IEEE 802.3 Ethernet Working Group Liaison
DRAFT Communication

Subject: Liaison to ISO/IEC SC 25 WG 3 from IEEE 802.3 in response to 3N926

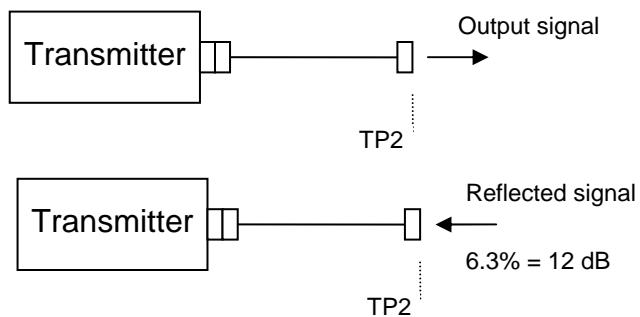
Q1. Do we understand correctly that this 12 dB requirement includes the optical return loss from the connectors that are plugged into the equipment at each end of the channel?

There was also a Note: *Please note; the ISO/IEC 11801 channel does not include the performance of the connecting hardware at the equipment interface.*

A1. The 12 dB optical return loss tolerance parameter is used in two **transmitter** performance requirements (RIN and TDP) defined at TP2, as illustrated below. The 12dB value is represents the worst case return loss when the transmitter is connected to a receiver.

At the receiver, the -12 dB reflectance requirement includes the connector.
